भारत सरकार
Government of India
विद्युत मंत्रालय
Ministry of Power
उत्तर क्षेत्रीय विद्युत समिति
Northern Regional Power Committee

Subject: Minutes for 59th Protection Sub-Committee Meeting.

59th Protection Sub-Committee Meeting (23rd April, 2025)-MoM

Minutes of
59th Meeting of Protection Sub-Committee (PSC) of
Northern Regional Power Committee

Points for Discussion

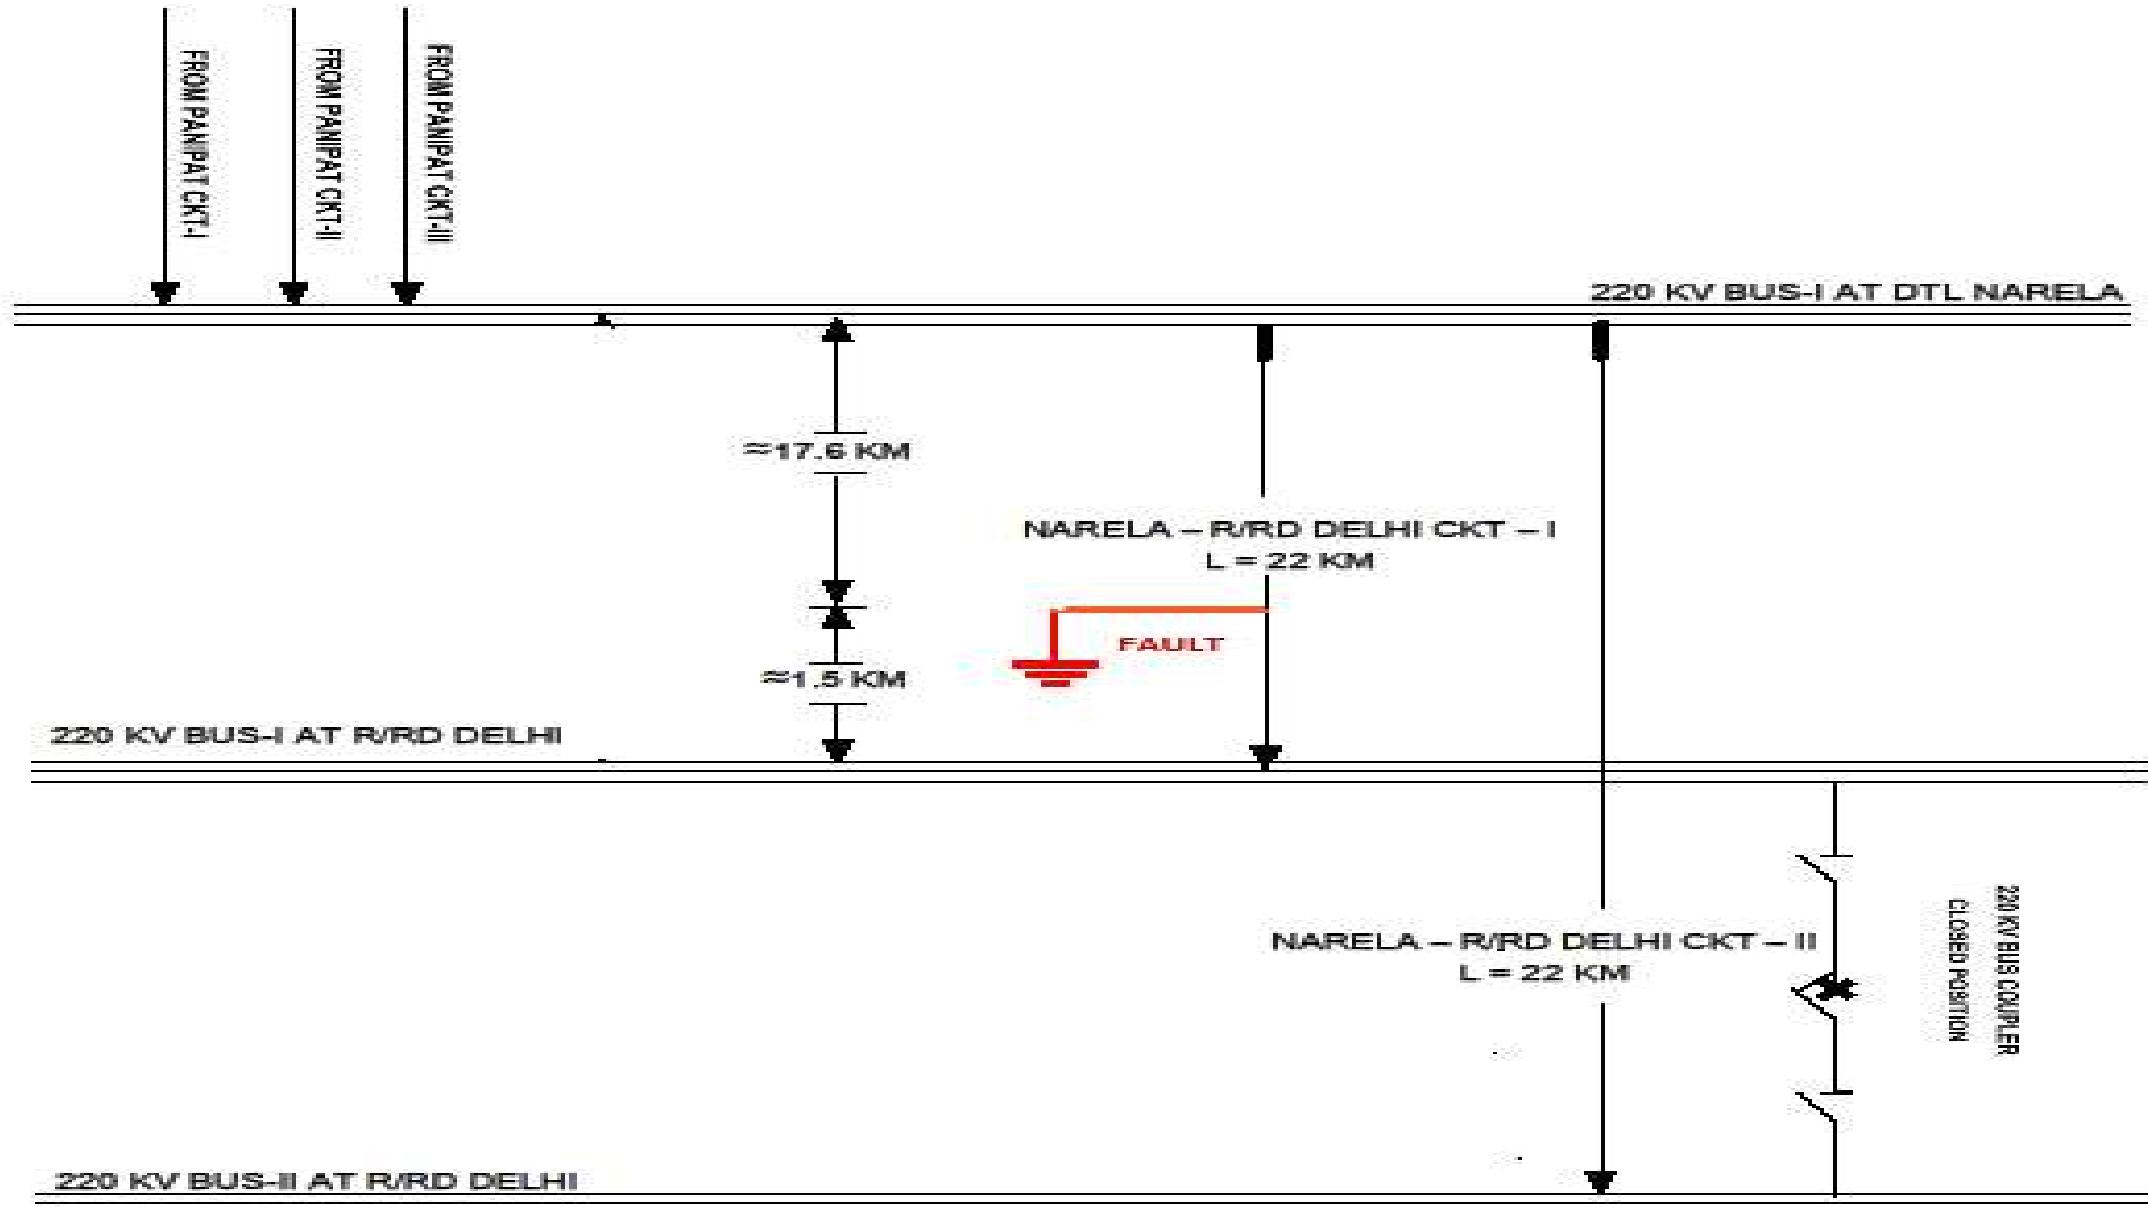
- i) Exact reason of fault in 220 KV Delhi RR(BB)-Narela(DV) (BBMB) Ckt-2 need to be shared.
- ii) DR/EL need to be shared from both the ends for each element.
- iii) Remedial action taken report to be shared.

DR of 400 KV AGE25L SL BHD2 PG-Bhadla 2 (PG) (AGE25L) Ckt-1

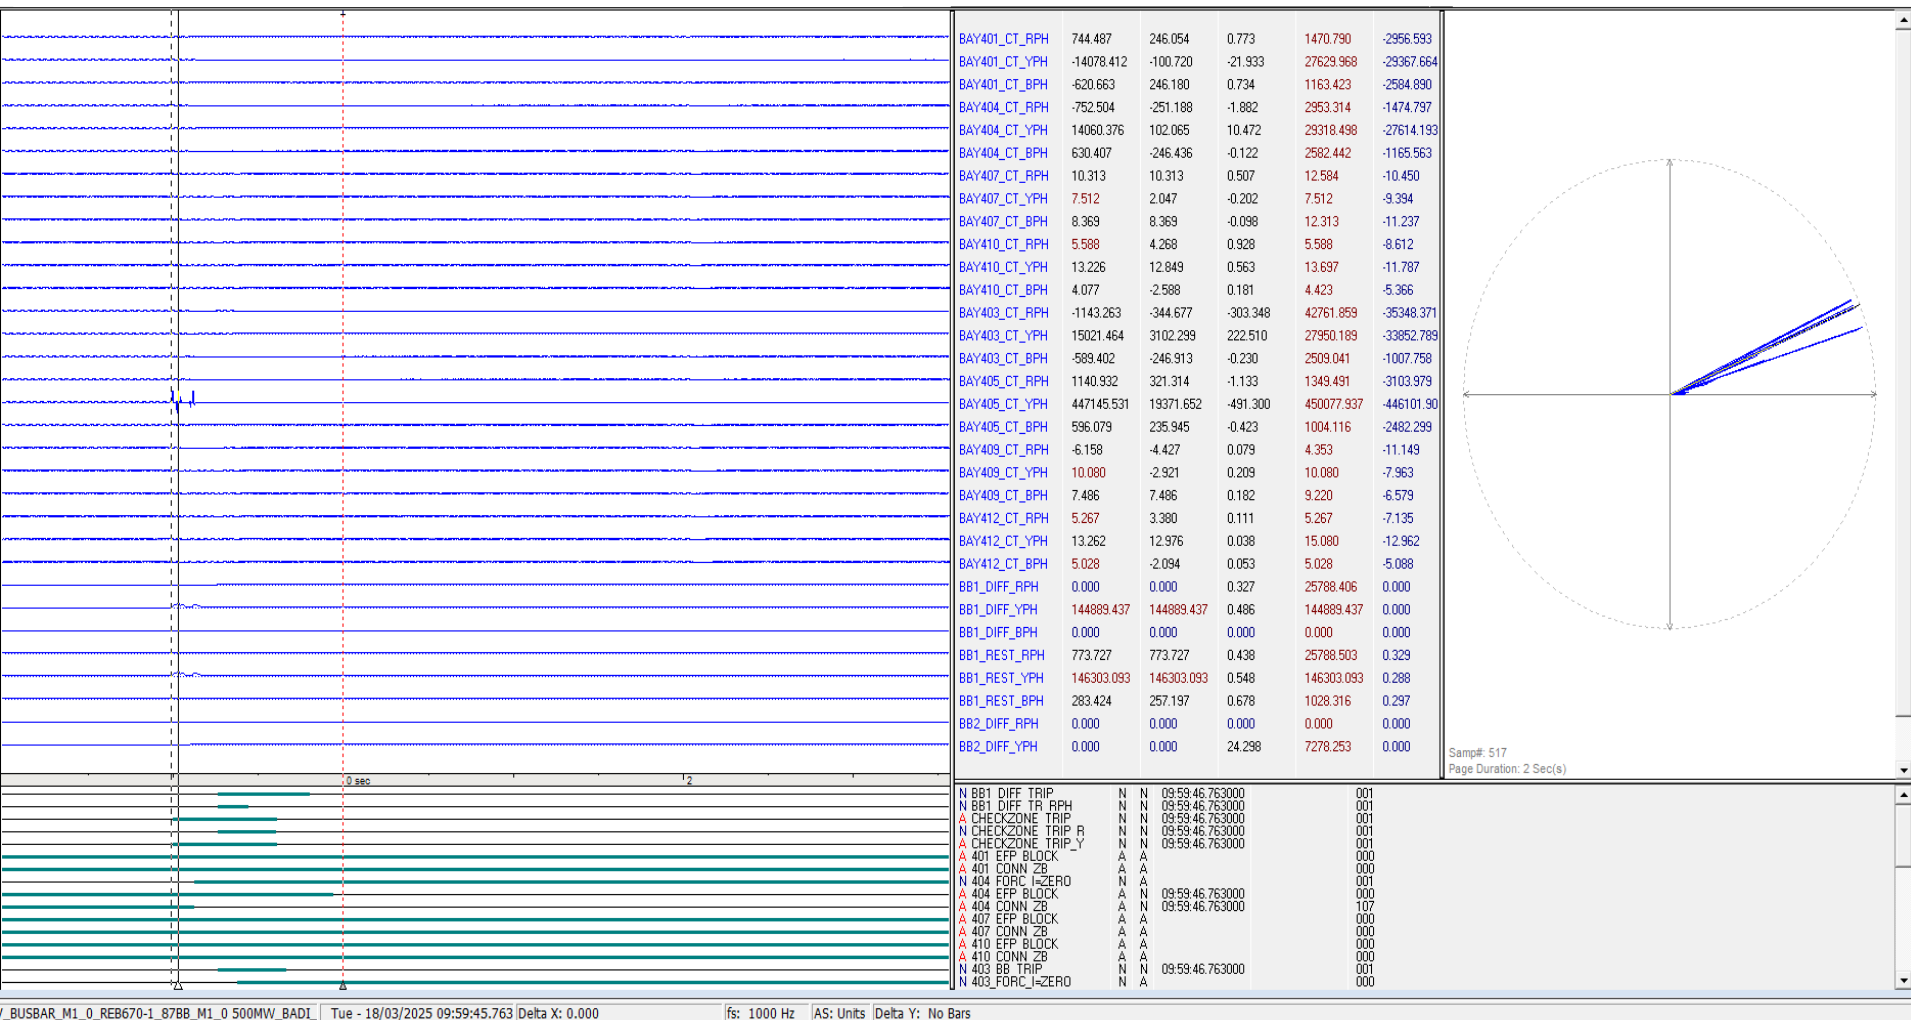
- ✓ Y-Phase Fault Observed.
- ✓ BUS BAR DIFFERENTIAL ZONE-1 – MAIN-1

DR of 400/33KV, 330MVA ICT-1 at AGE25L(IP)

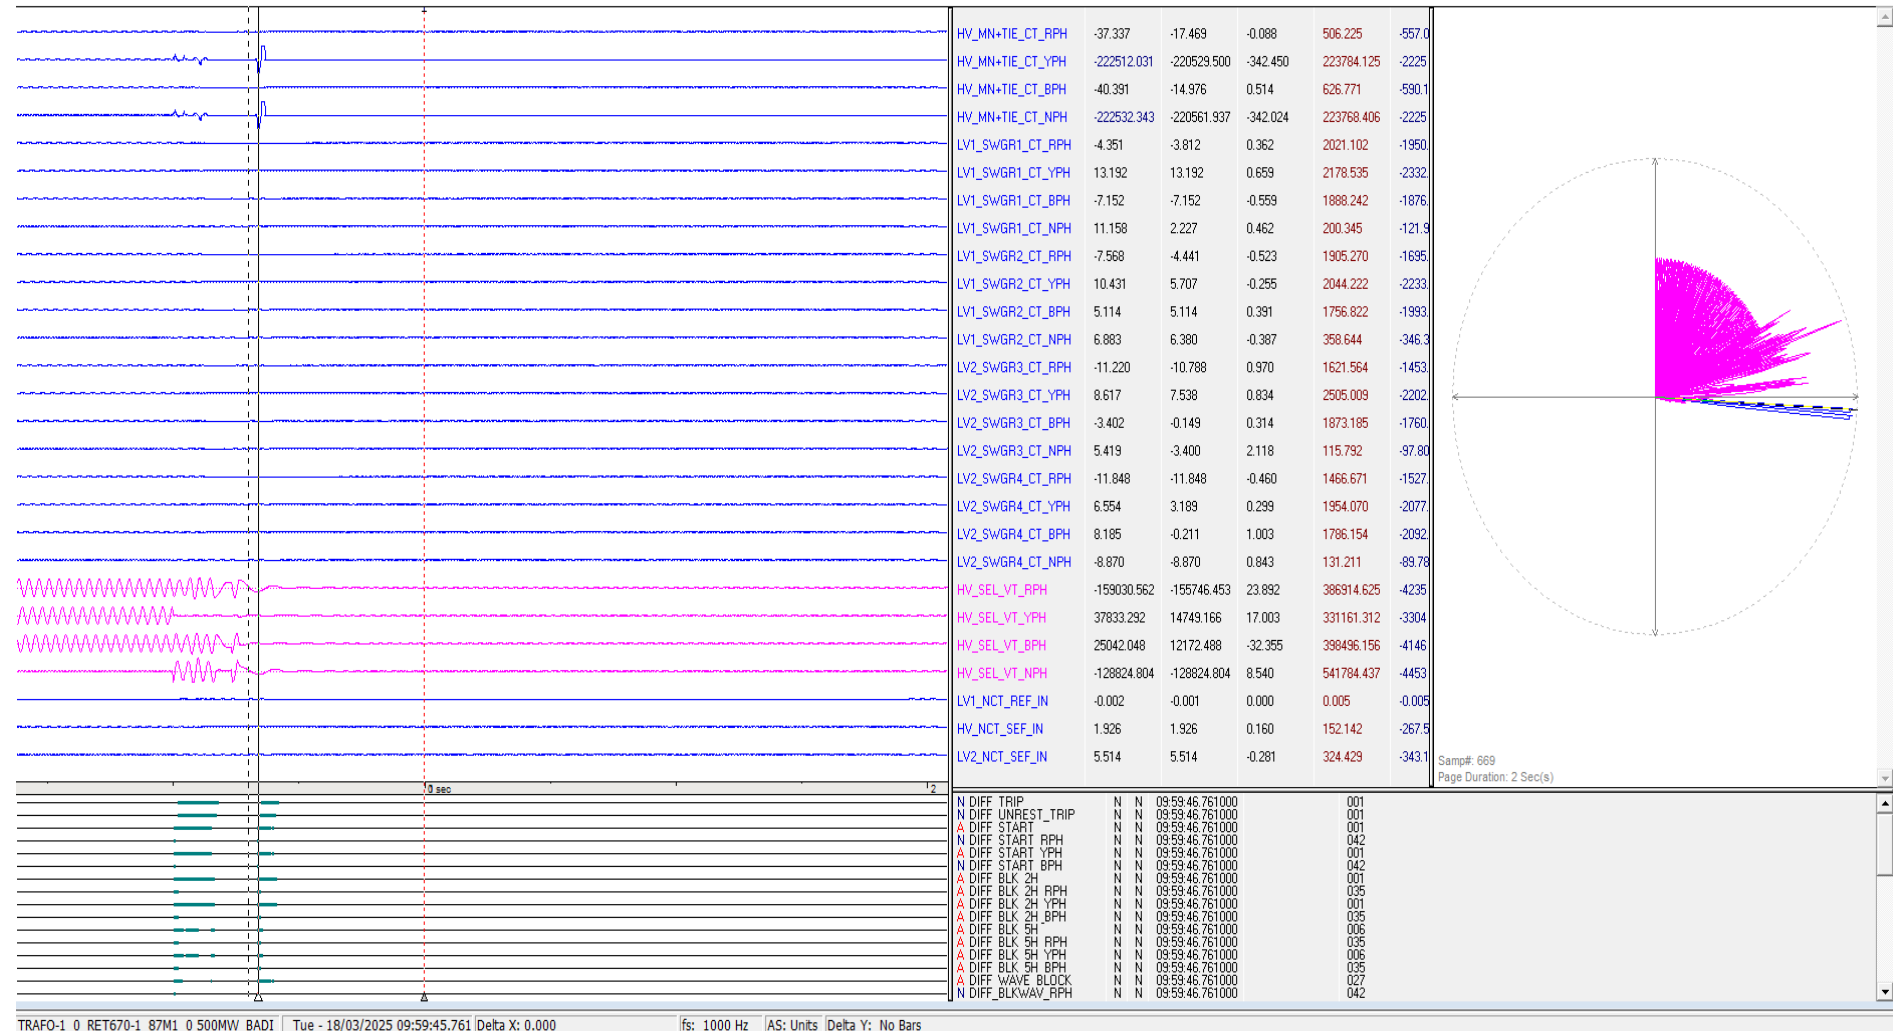
✓ Y phase Differential protection operated due to Y phase fault .

PMU Plot of Active Power (MW) at AGE25L(IP)

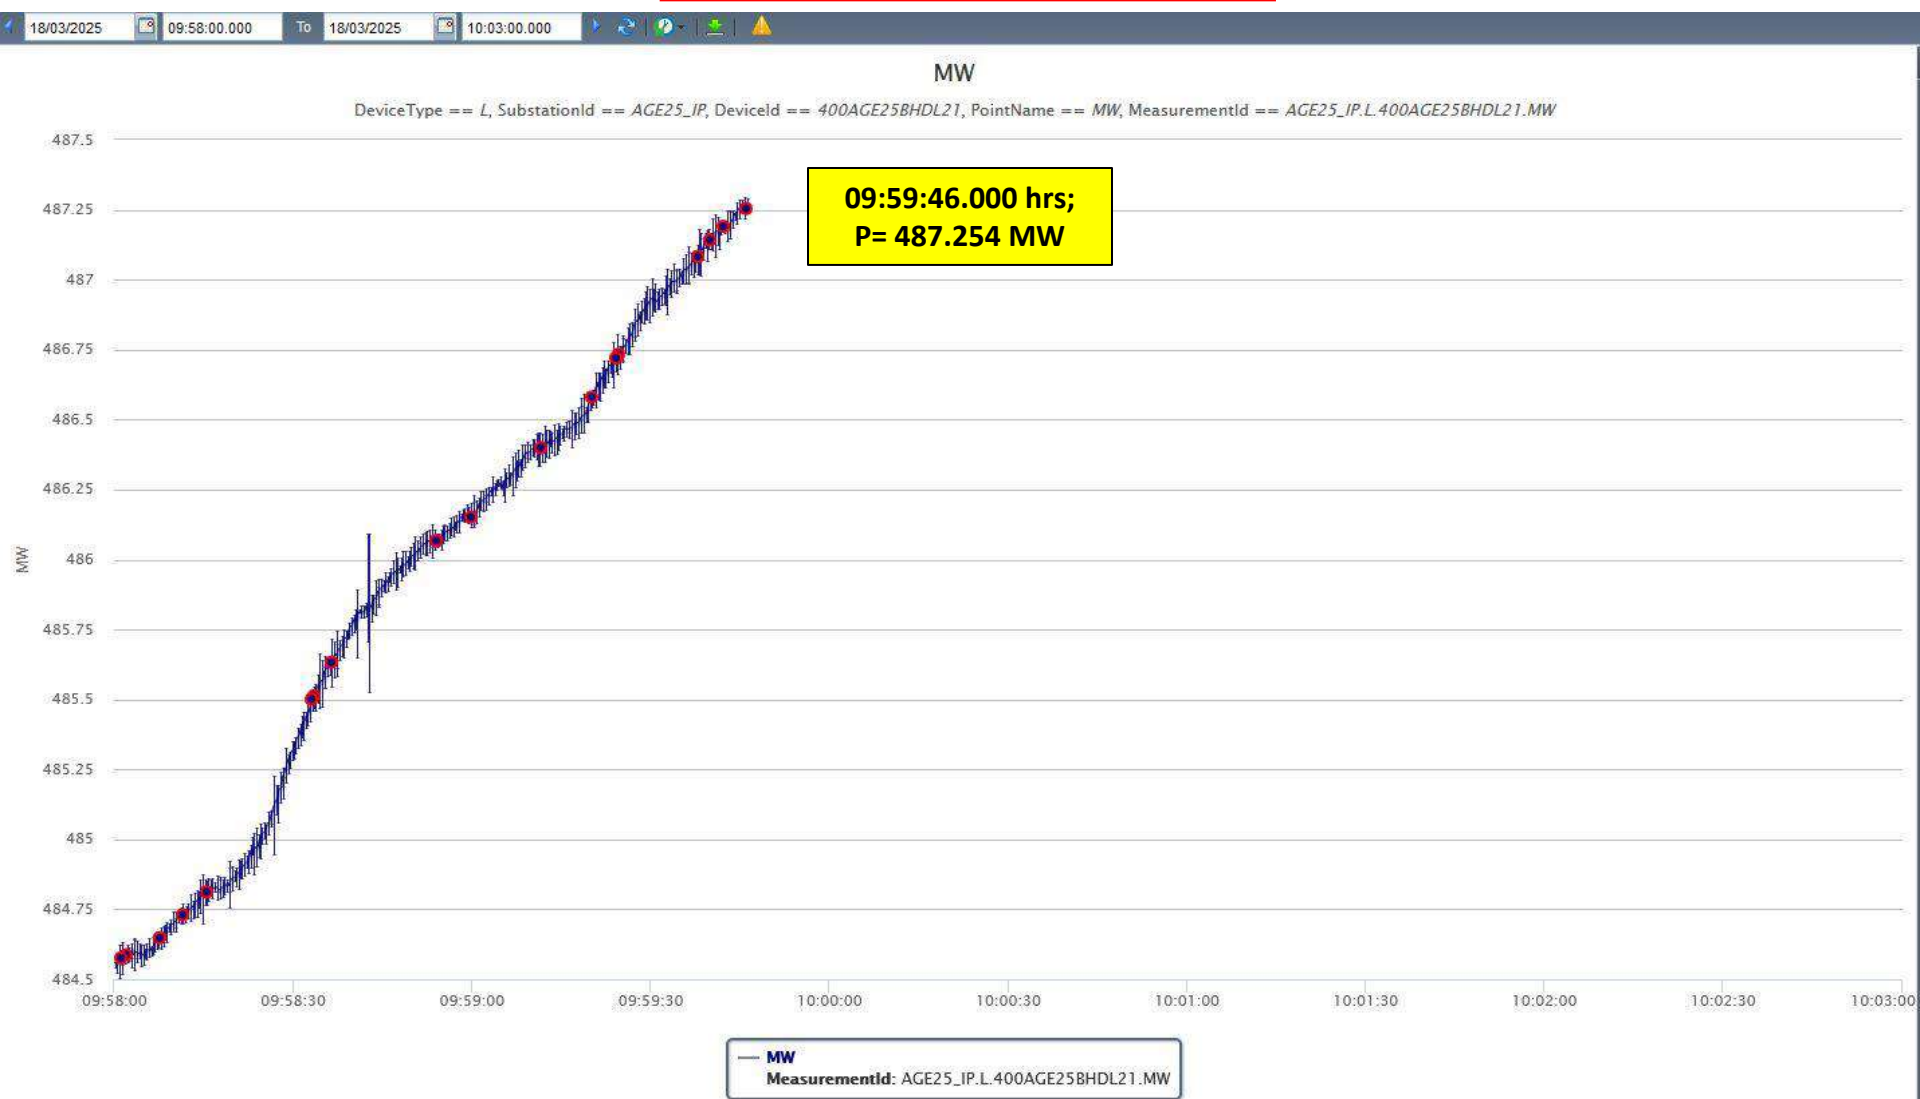
✓ PMU data not available after the event time.

PMU Plot of Active Power (MW) at AZRMP(IP)

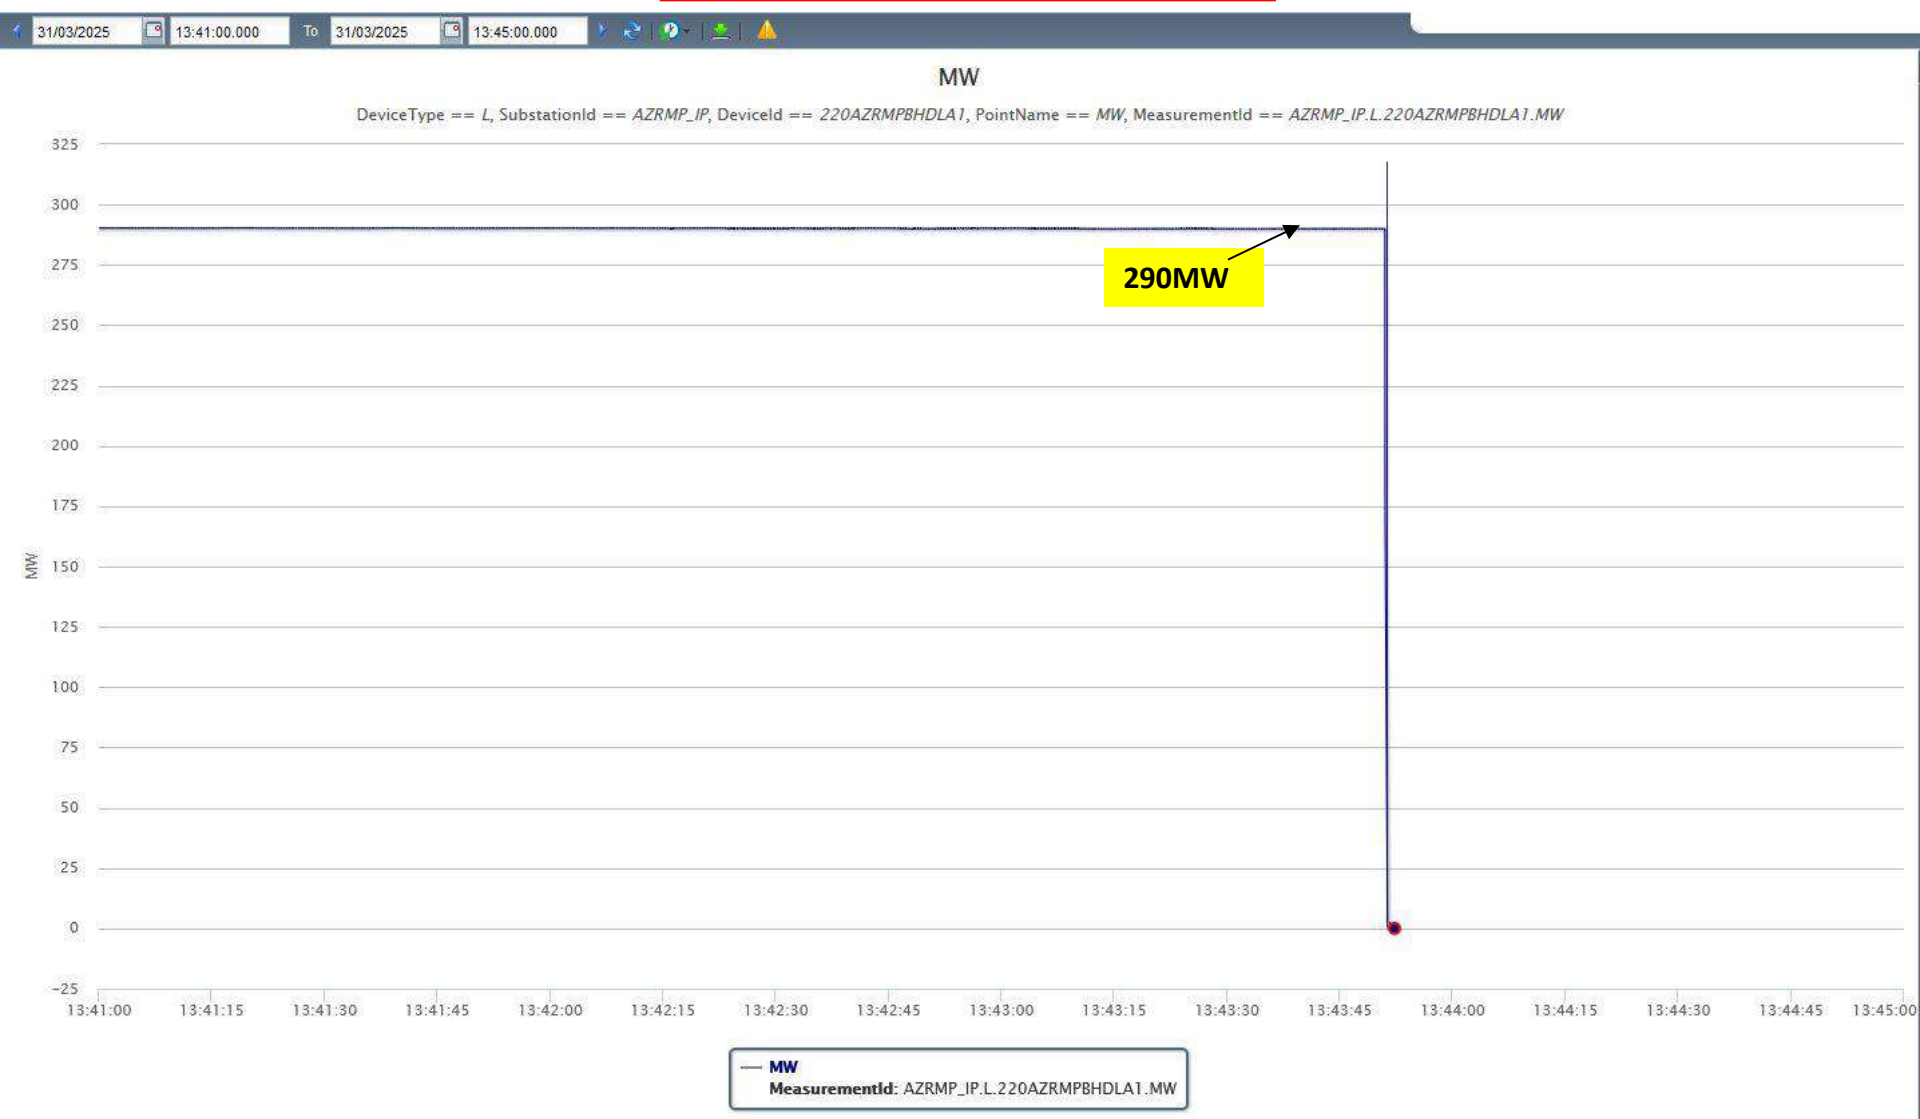
✓ As per PMU, generation loss of approx. 290 MW at AZRMP(IP)
